Iowa City Historic Preservation Commission

Thursday
July 9, 2015
5:30 p.m.

Historic Review for 411 E. Davenport Street

Historic Review for 828 Dearborn Street

711 E. Davenport St.
egress window well

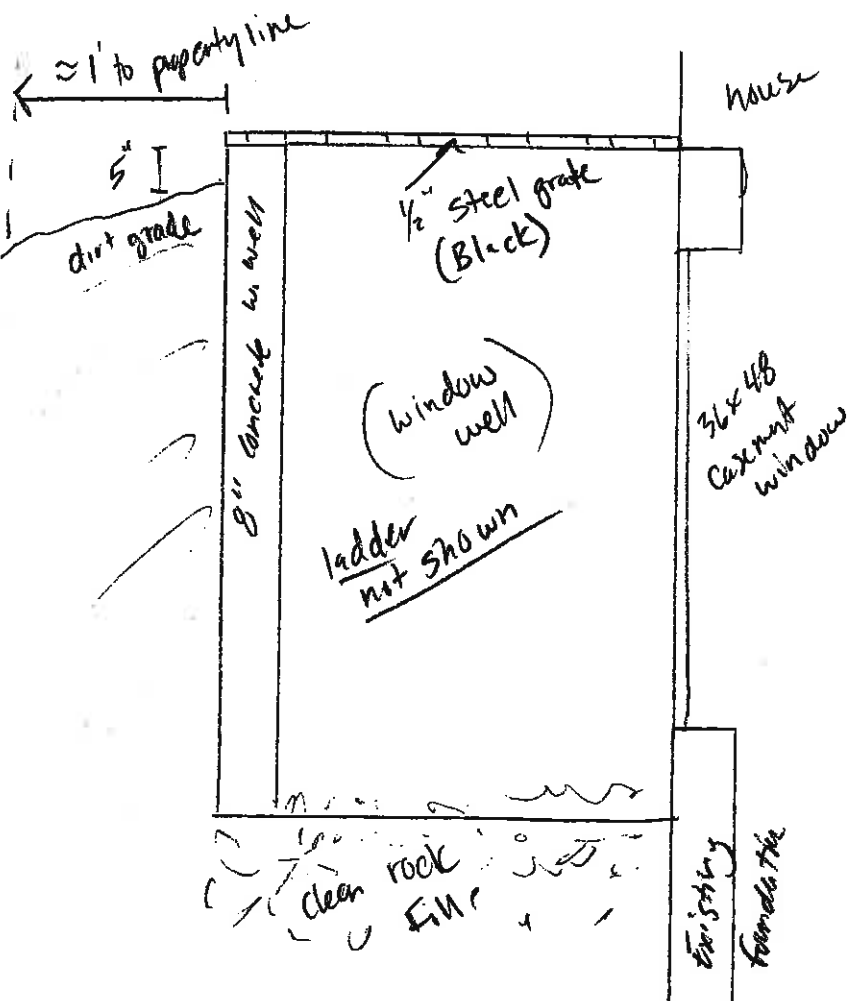
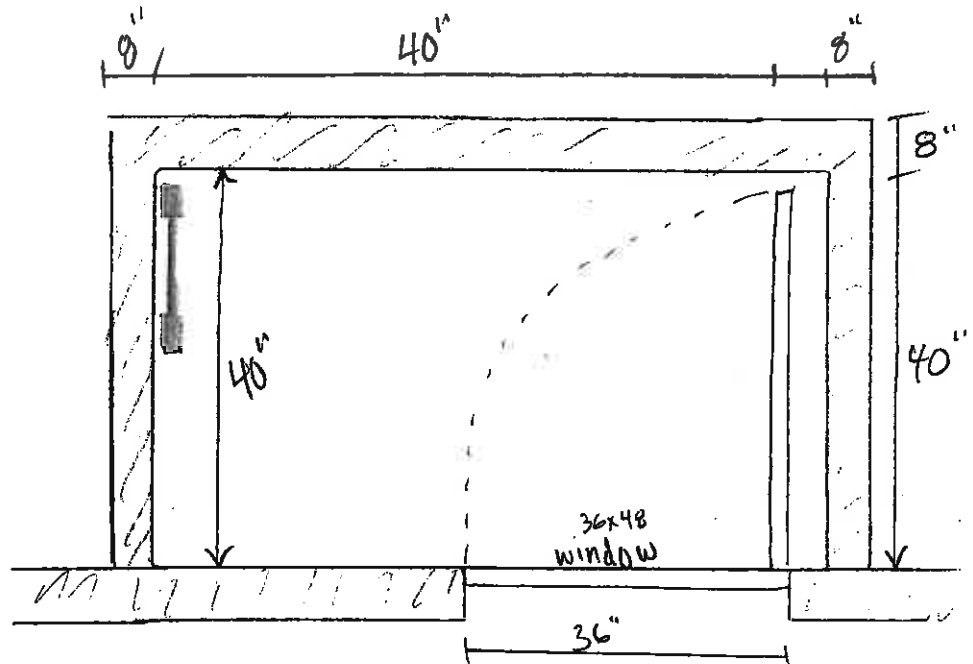
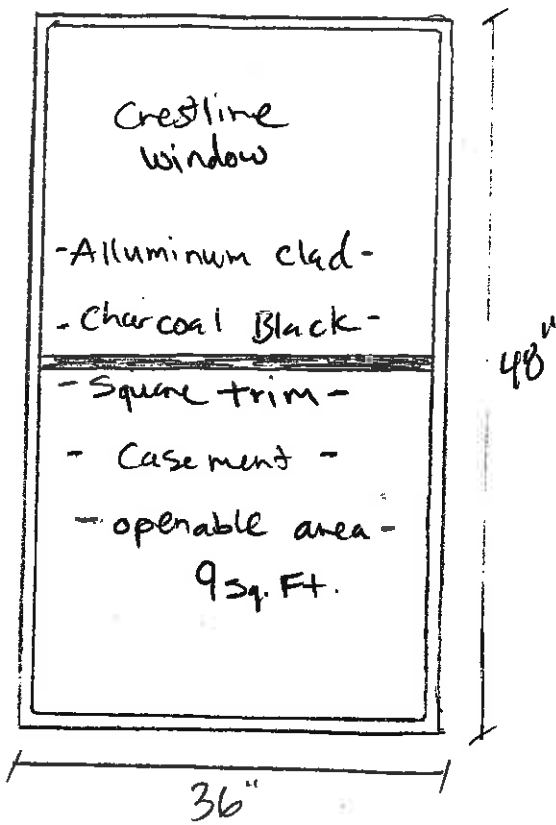
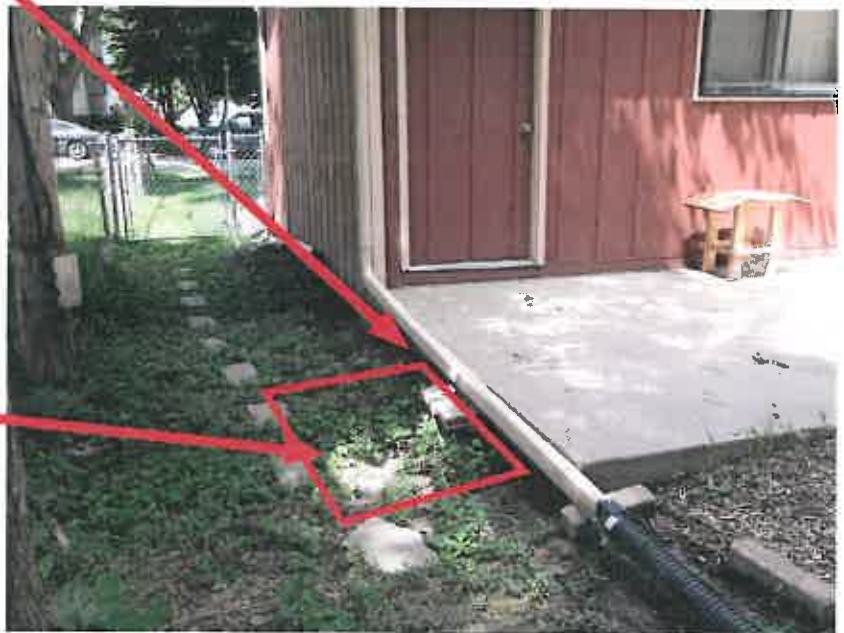
The applicant is proposing to add a basement egress window to the west side of the basement wall. The basement extends under the concrete patios on the front and back of the house. The egress window would be in the side foundation wall of the rear patio. (see photo) The applicant proposes to use a Crestline metal-clad casement window painted dark to match the other windows on the property. The window well would be cast concrete extending about 5 inches above grade. Because of the adjacent porch slab and the proximity to the property line, the applicant will cover the egress window with a steel grate compliant with city code.

The guidelines recommend using materials that appear similar to the existing foundation material for new window wells and using a smooth faced concrete foundation for new construction. New egress windows should match the size, trim, use of divided lights and overall appearance of other windows in the house. Casement windows are allowed only for egress when they are not original. The use of metal-clad, wood-frame combination is acceptable.

In Staff's opinion, the use of a metal-clad Casement window with wide muntin bars adhered to both sides of the glass to approximate the look of a double-hung window is appropriate in this basement egress window option. Since the foundation is not visible on the house, the use of a smooth poured concrete for the window well is preferred. Since the egress location is adjacent to a patio and a pedestrian path in the yard, a cover over the window well is necessary for safety concerns. The building officials prefer a metal grate that can be lifted and is recognizable by the fire department. Given the low profile, about 2 inches over the wall of the window well, this metal grate should not impact the historic character of the existing house.

Move to approve a Certificate of Appropriateness for the project at 411 E. Davenport Street as presented in the report.

928 Dear John Remodel of Ex+ Addition

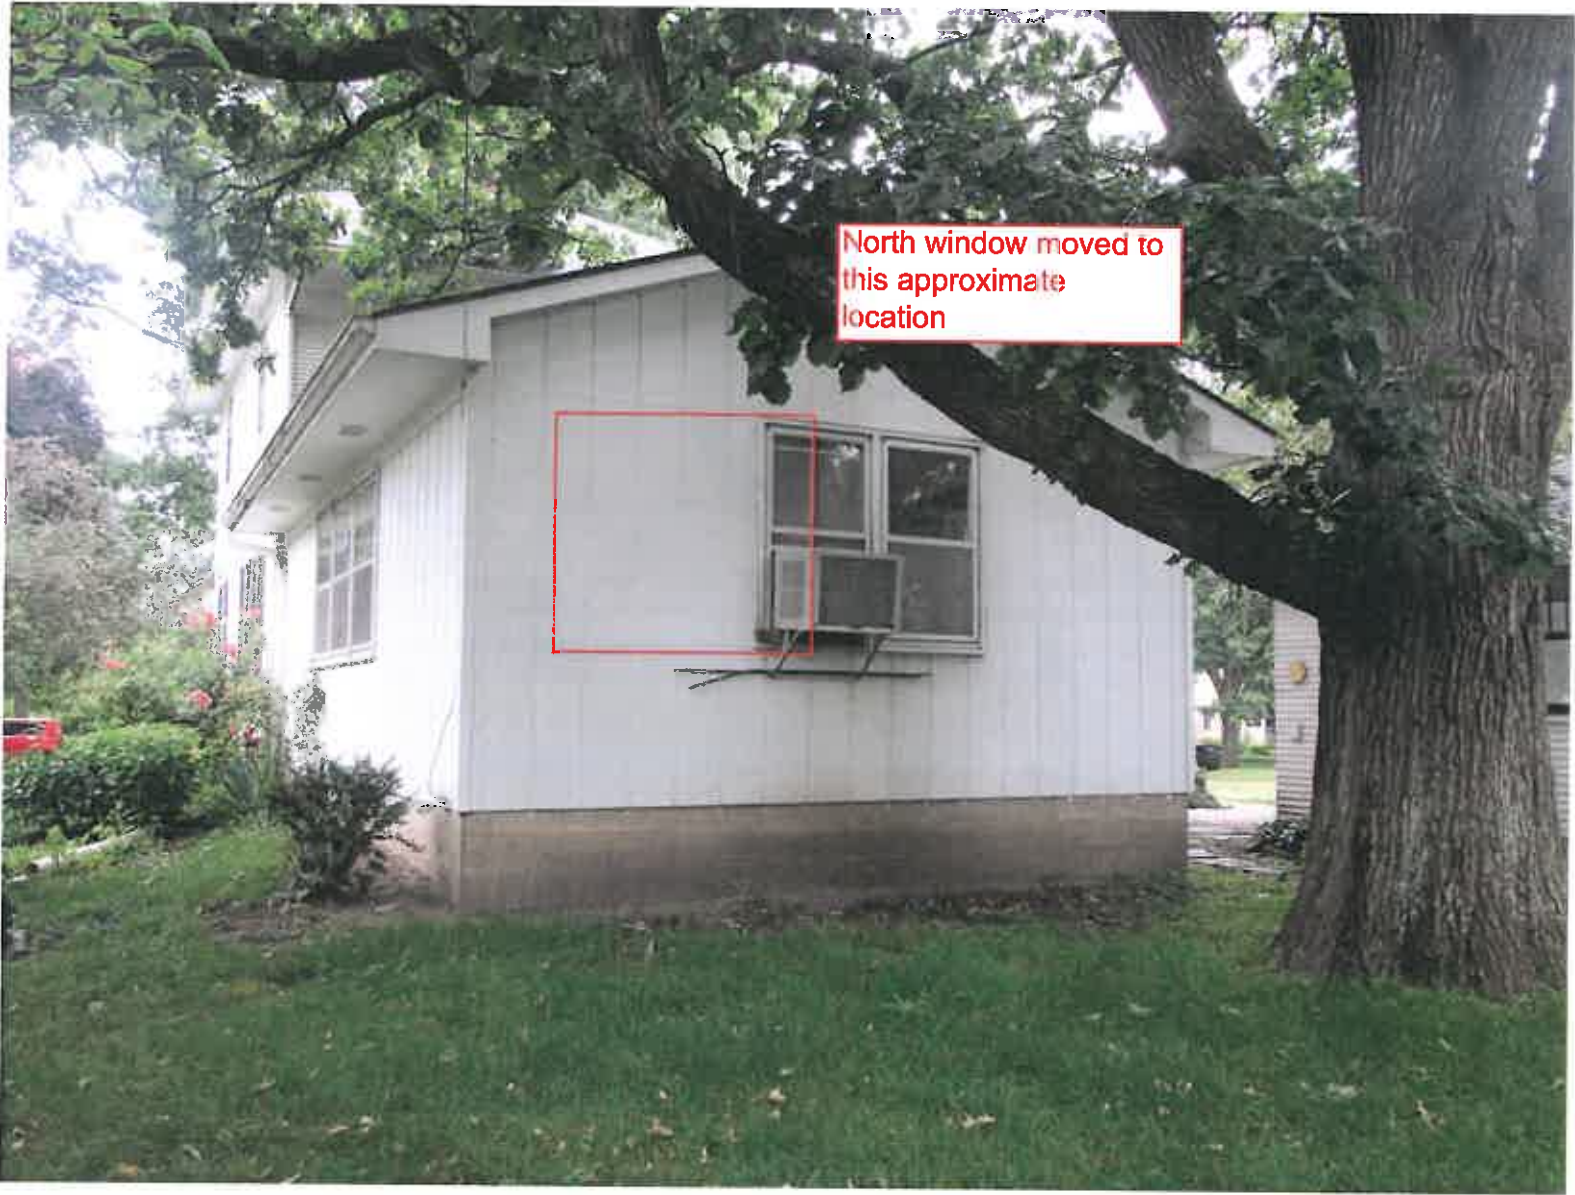
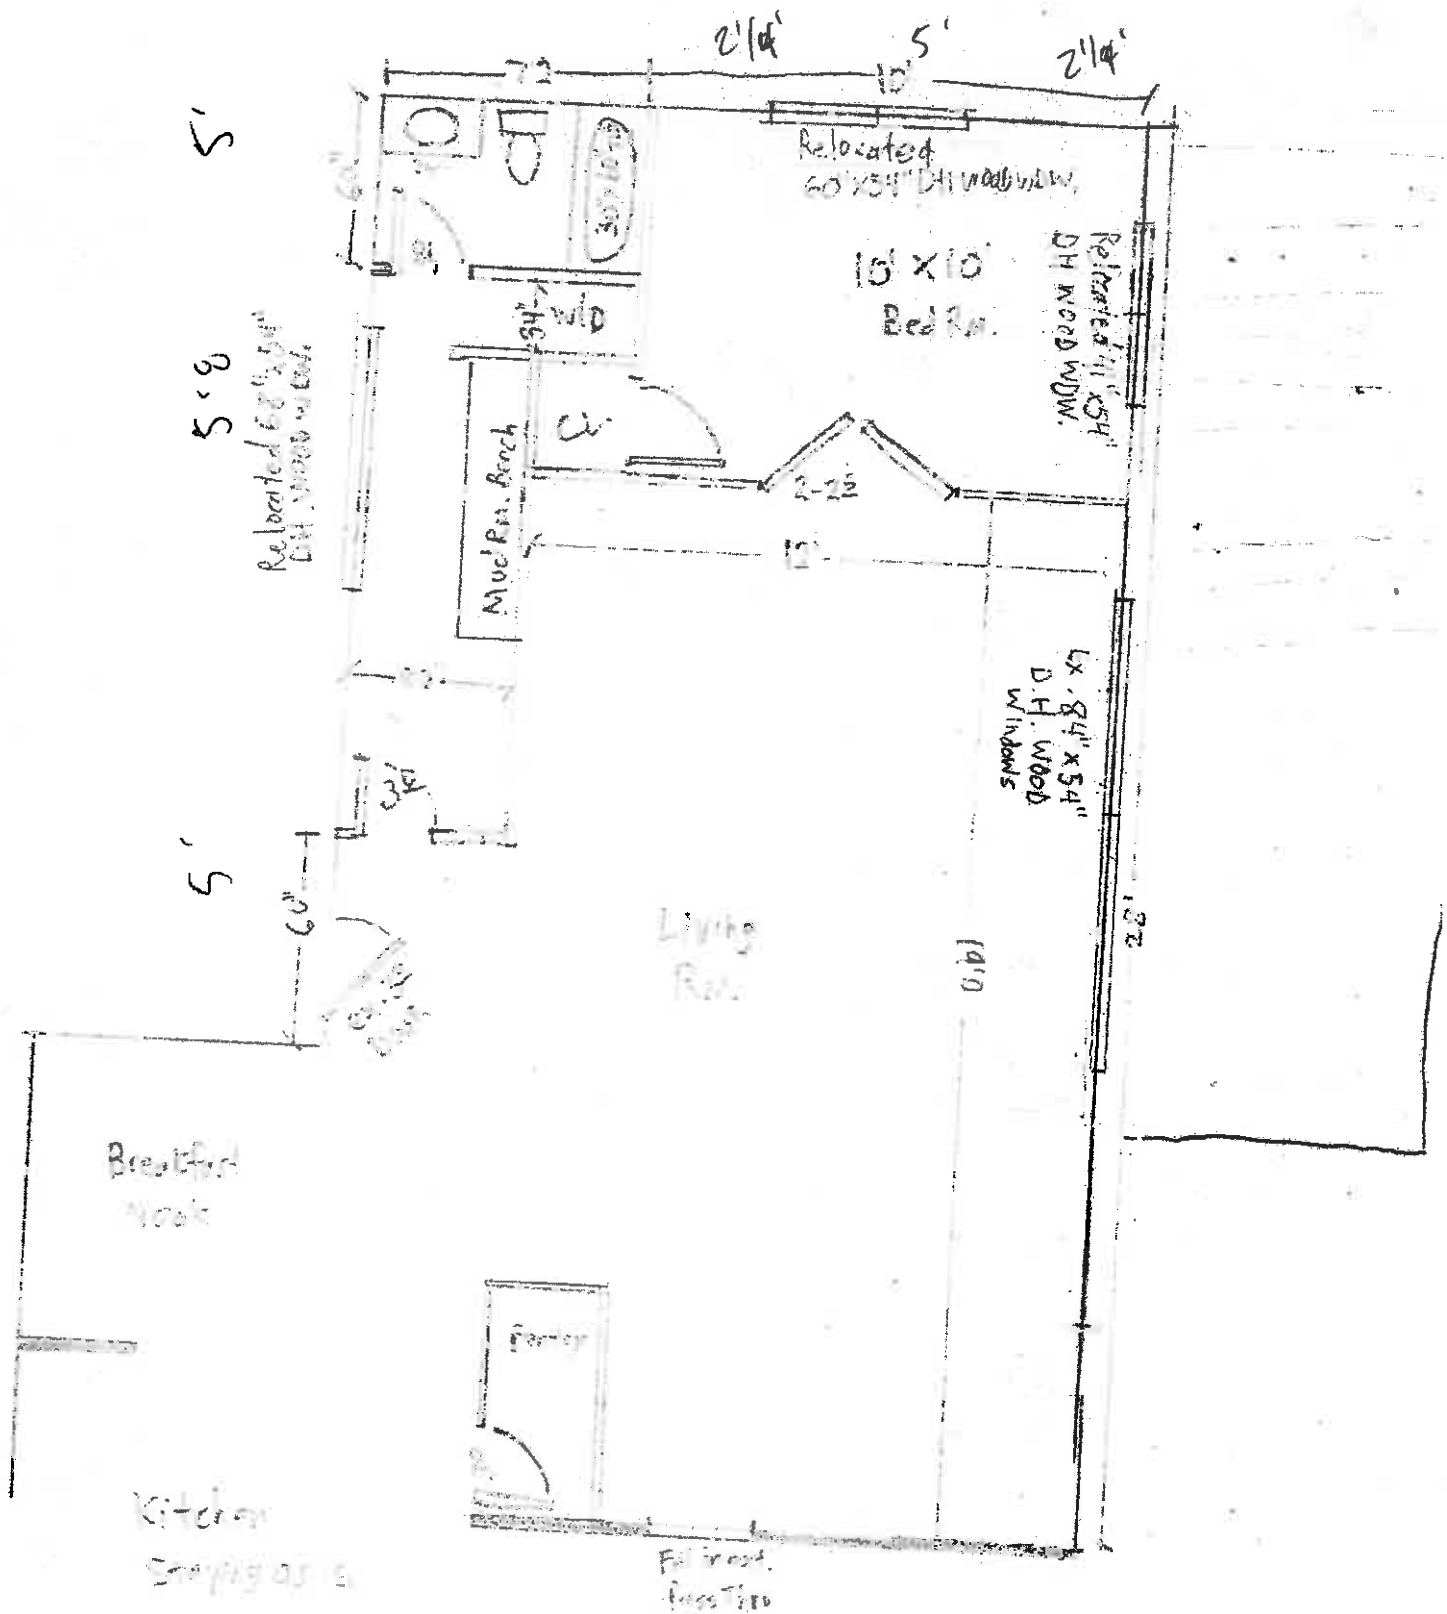
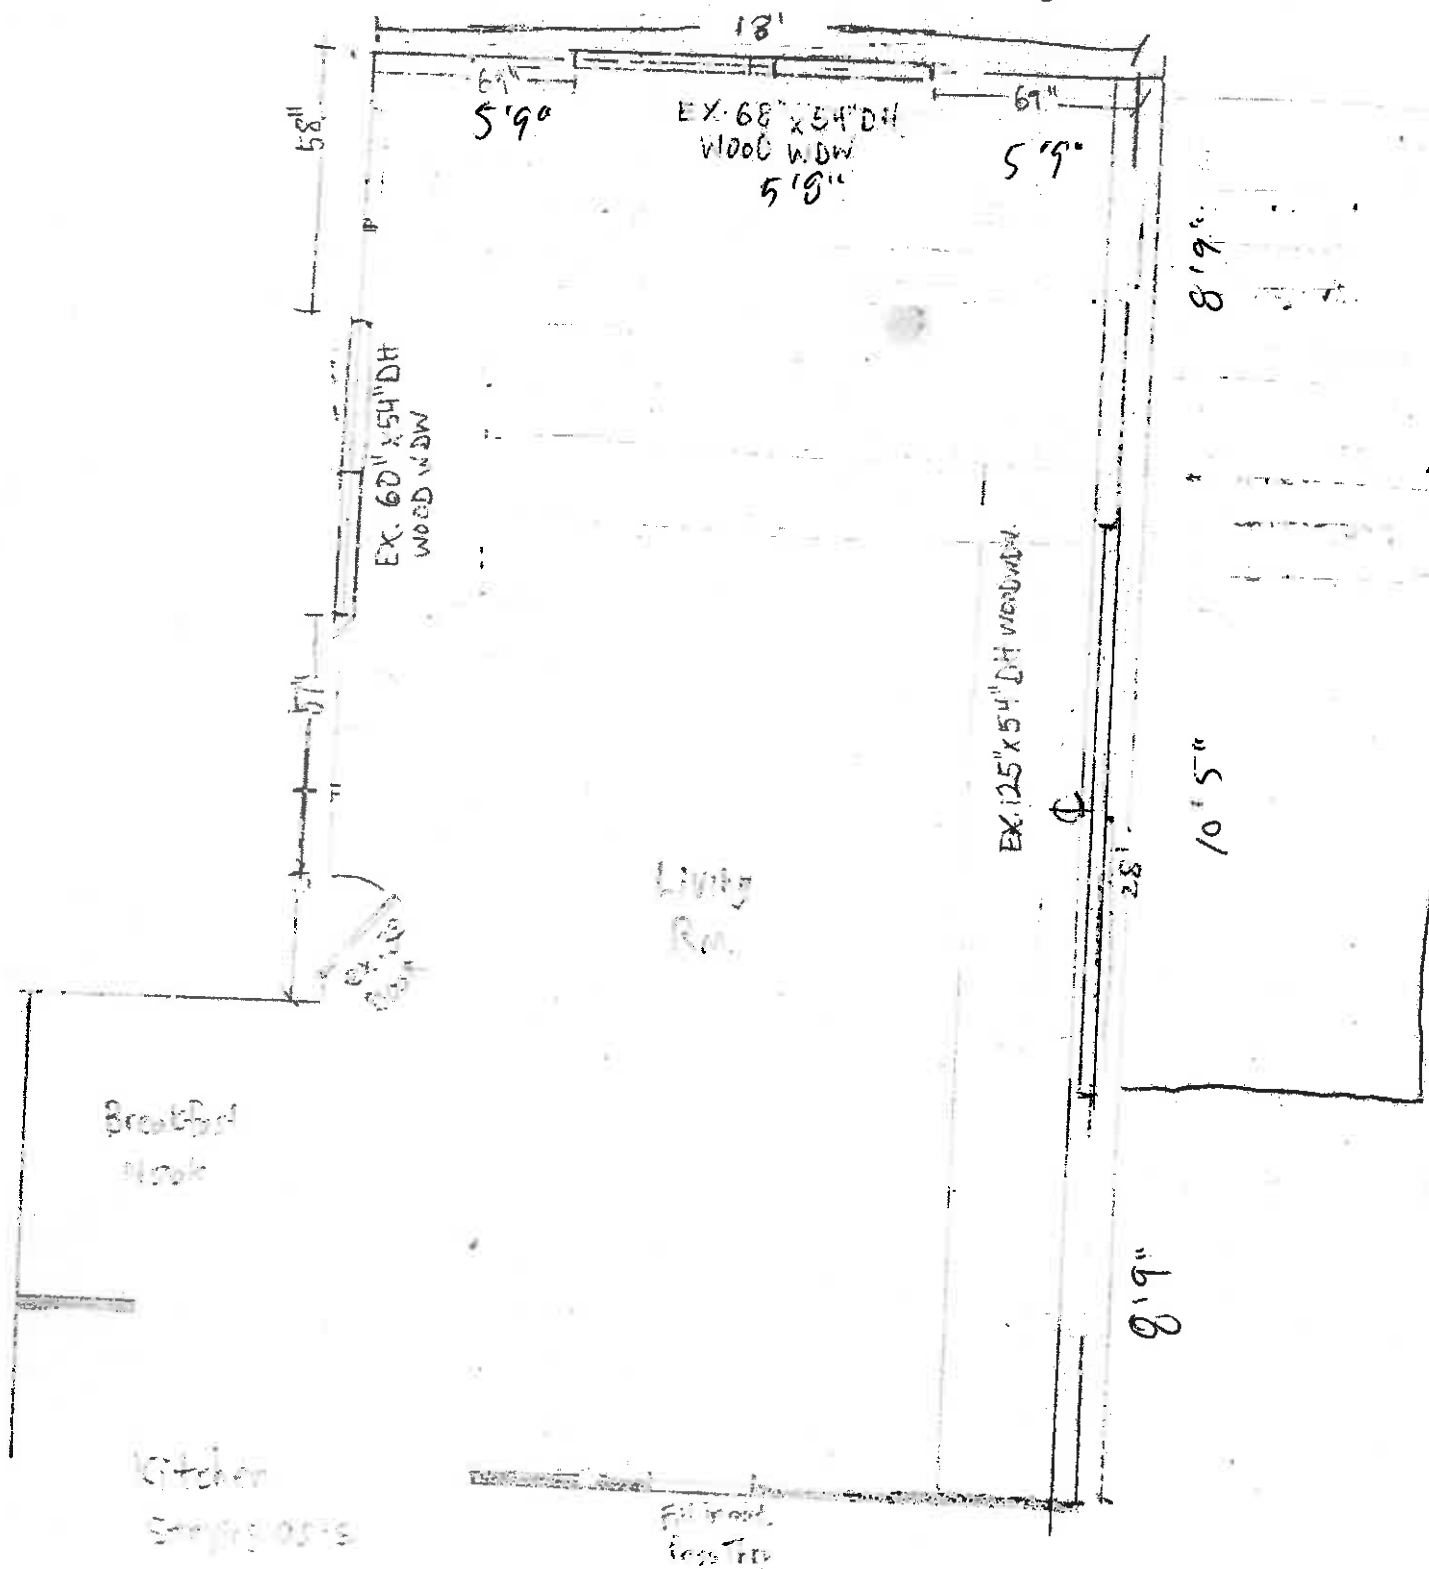
The applicant is proposing to remove the modern T-111 siding from the single-story rear addition and replace it with wood bevel siding with a smooth finish and lap size to match the existing historic house. The corners will be beveled and the siding will be painted to match the existing. While this work is done, damaged siding on the historic portions of the house will be replaced with the same material. Gutters and downspouts on the historic house and addition will be replaced.

Windows in the rear addition will be moved as follows:

- On the south side, the three ganged windows will be separated so that the two windows to the west will remain in their existing location and the window on the east will be moved 9 ½ feet east so that it is centered in a newly remodeled interior space. See attached photo.
- The 5'- 8" wide window pair on the east end of the addition will move to the north wall of the addition and be centered between the existing door and the corner.
- The 5 foot wide window pair on the north side of the addition will move to the east wall and be positioned about 2 ½ feet from the southeast corner so that it is centered in the wall of the remodeled interior space.

The jamb and sill trim on these windows will be extended to approximate the trim on the historic portion of the house. The windows have a non-removable brick-mold that prevents the trim from exactly replicating the profile of the historic trim. Similarly, the head of the windows on the north and south sides are in the trim board under the soffit so no additional trim will be added here. The head trim for the east window will be extended to approximate the historic window head trim.

In Staff's opinion, the proposed project will help the modern rear addition to blend in with the historic house. The non-historic siding will be replaced so that the new siding matches the original house. The deteriorated gutters, downspouts, and deteriorated siding will be replaced with appropriate matching materials. The modern window placement on the south side will be improved by moving one of the three windows further east. With the exception of the single window, all of the windows on the addition will then be paired like most of the windows on the historic portion of the house. Relocating the windows on the north and east sides of the addition will make no impact on the historic character of the house but will allow the applicant to remodel the interior space so that it is more functional.

Move to approve a Certificate of Appropriateness for the project at 828 Dearborn Street as presented in the report.
